CITY OF BOULDER
PLANNING BOARD MEETING AGENDA
DATE: September 2, 2015
TIME: 5 p.m.
PLACE: 1777 Broadway, Council Chambers

A. SITE AND USE REVIEWS: Applications under case no.'s LUR2015-00010 and LUR2015-00011, are for the proposed redevelopment of the 10.9 acre former Sutherlands Lumber site including 3390 Valmont Rd.; and 3085, 3155, 3195 Bluff St. within the northern portion of Boulder Junction to create a new mixed use, mixed income neighborhood comprised of seven distinct areas:

CITY OF BOULDER
PLANNING BOARD AGENDA ITEM
MEETING DATE: September 2, 2015

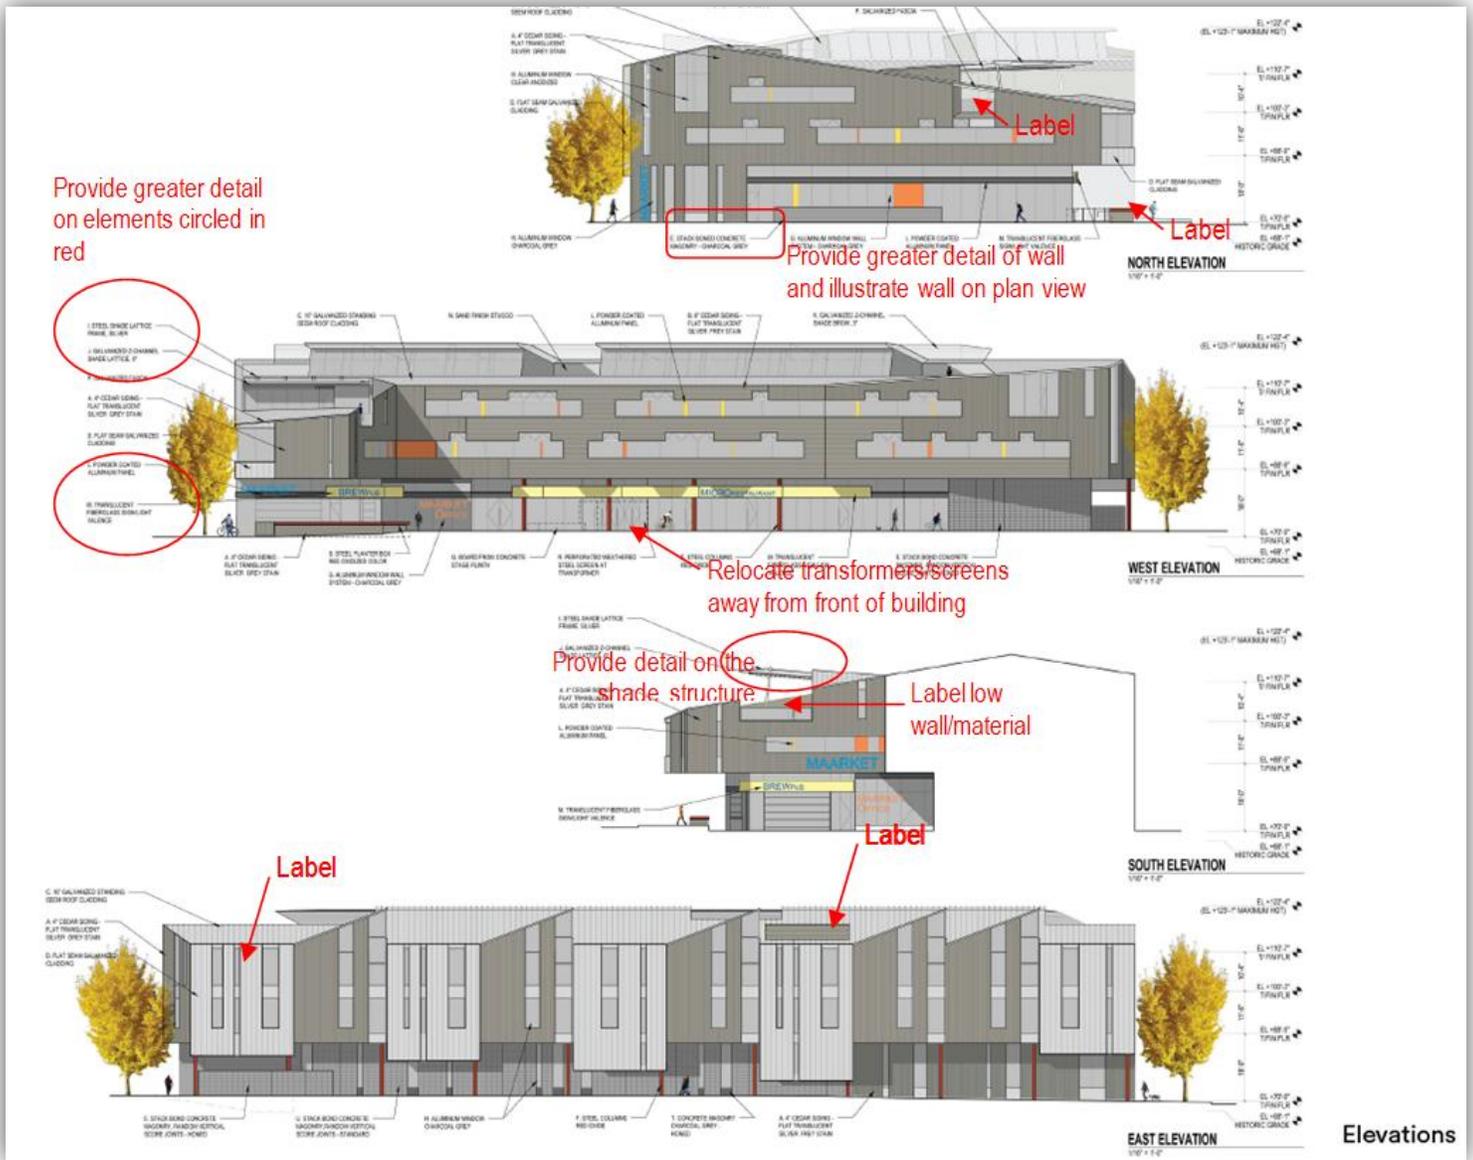
14. The east elevation is essentially a 250 foot long blank wall adjacent to the multi-use path. The Rail Plaza District Guidelines state, “orient buildings to Junction Place as well as to the tracks. If feasible, place active uses on the first floor. Consider making the track-side frontage a car-free zone with pedestrian amenities. Because this path is a public way, additional windows and/or doorways such as roll-up doors would provide enhanced access and activity along the east elevation.

15. The perspective shown below illustrates the second floor of the building projecting over the first floor and illustrates that there may be a view of the Flatirons available from the location of the image. The TVAP General Design Guidelines state, “consider opportunities to frame or preserve views of the Flatirons to the southwest.” Therefore, a more definitive analysis of this potential should be performed using Google Earth. The projection of the second floor may impose on this viewshed and may not actually contribute to either framing the street or creating pedestrian interest when the second floor cantilevers over the first floor. Additional exhibits will assist staff in determining if the building’s configuration meets the design guidelines and site review criteria for:
 - Blocking views
 - Pedestrian scale articulation and building elements

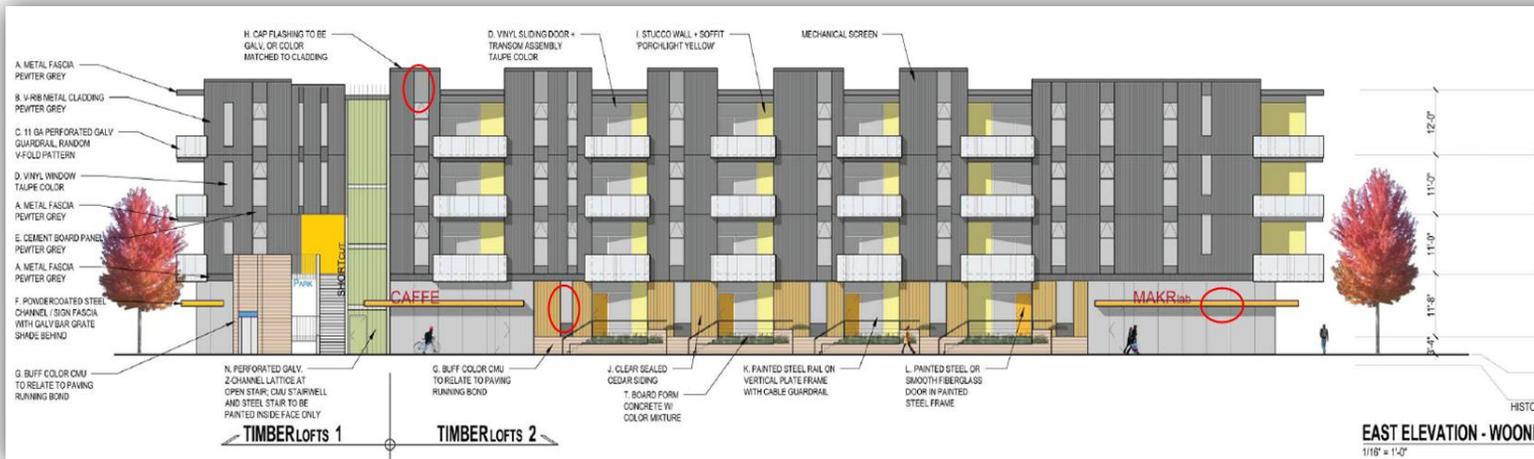
PROVIDE LABELS OF GROUND FLOOR USES TO DISTINGUISH THE VARIOUS SPACES

Level 1

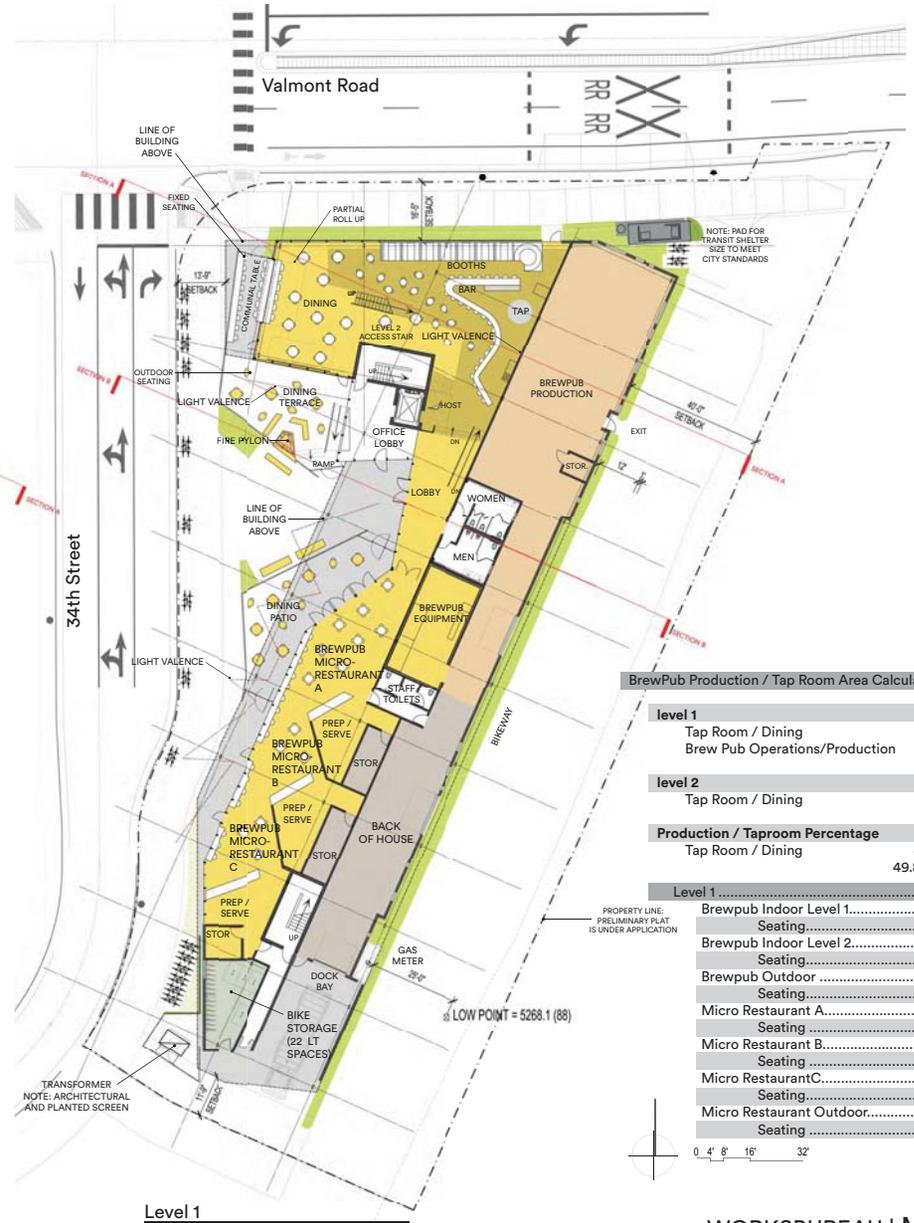
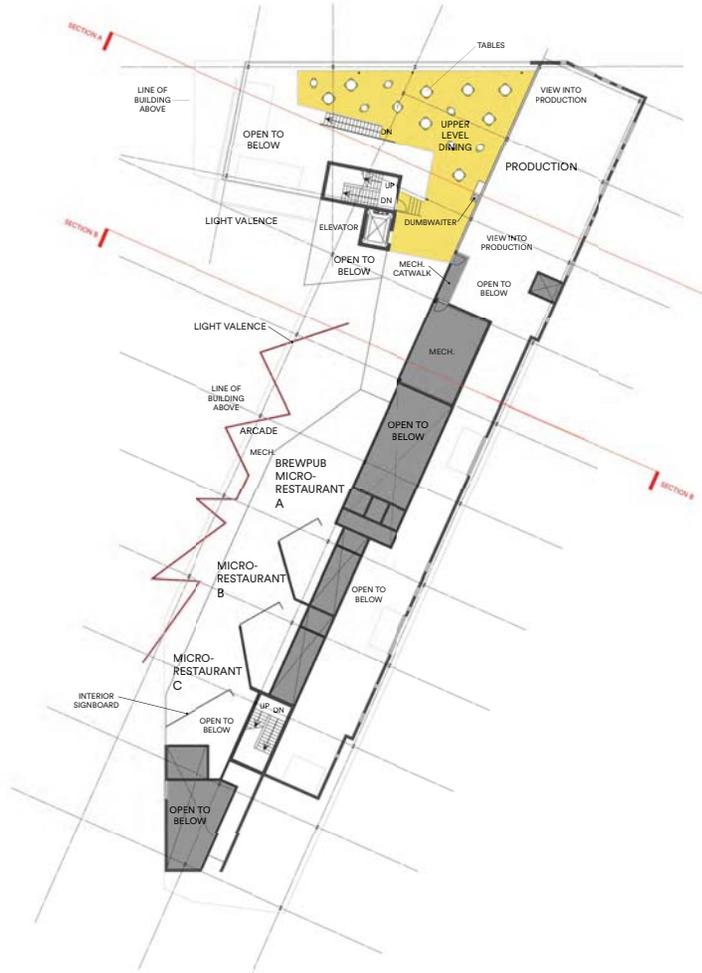
- On sheet 47, Level 1 and Level 1 Mezzanine: a number of floor plan elements and rooms are not labeled please label all of the

- On sheet 47, Level 1, the outdoor stage/plinth needs additional information not only on the plan set with details, but also with regard to programming of the space (see Use Review comments below). The “plinth” implies that the stage is elevated, however, there are no details, please provide greater information in the resubmittal of the height, materials, covering (if any), location of speakers, etc.
- Note that the floor plans must indicate a net square footage rather than gross square footage, as it is the net from which the parking requirements are established. For elements that are not factored into a net floor area total, refer to the land use code

3. On sheet 47, Level 1 and Level 1 Mezzanine: a number of floor plan elements are not labeled, to provide greater clarity please label all of the elements shown on the plan. Note that a separate floor plan illustrating specific tenant finish of the brew pub must be submitted for the Use Review including clear delineation of the kitchen space and the number of seats planned.

On sheet 47, Level 1 and Level 1 Mezzanine: a number of floor plan elements and rooms are not labeled please label all of the elements shown on the plan. Those include, but are not limited to those shown below as indicated with red arrows.
